MIL-C-49142
AMENDMENT 2
13 September 1989
SUPERSEDING
AMENDMENT 1
10 January 1983

MILITARY SPECIFICATION

CONNECTORS, PLUGS AND RECEPTACLES, ELECTRICAL, TRIAXIAL, RADIO FREQUENCY, GENERAL SPECIFICATION FOR

FIGURE 1. Keying configurations (TRB only).

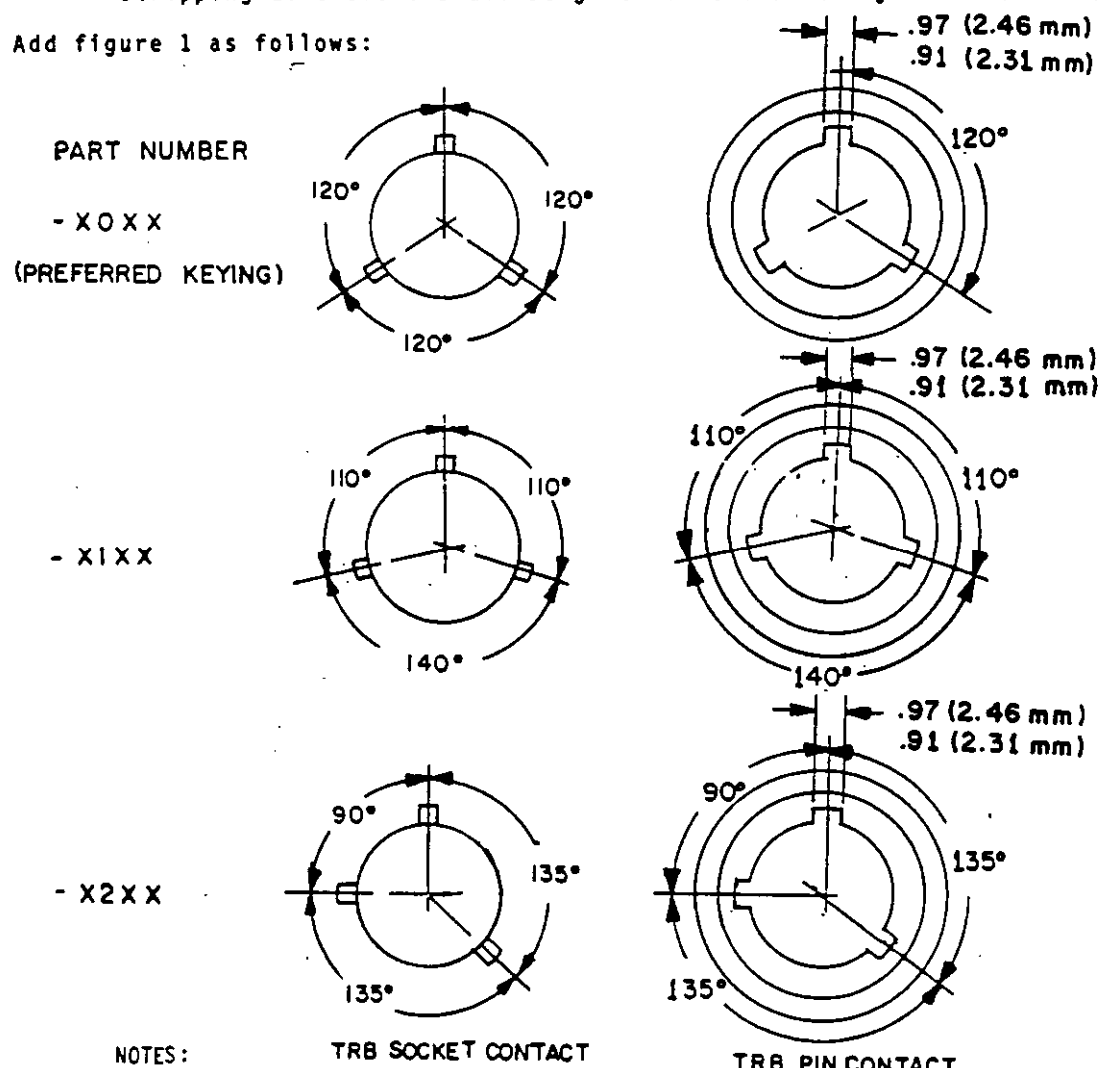
* Add figure 1 as follows:

NOTES:
1. Bayonets shall be dimensioned in accordance with MIL-STD-348, unless otherwise specified.
2. Tolerance on all angles shall be ±1°.
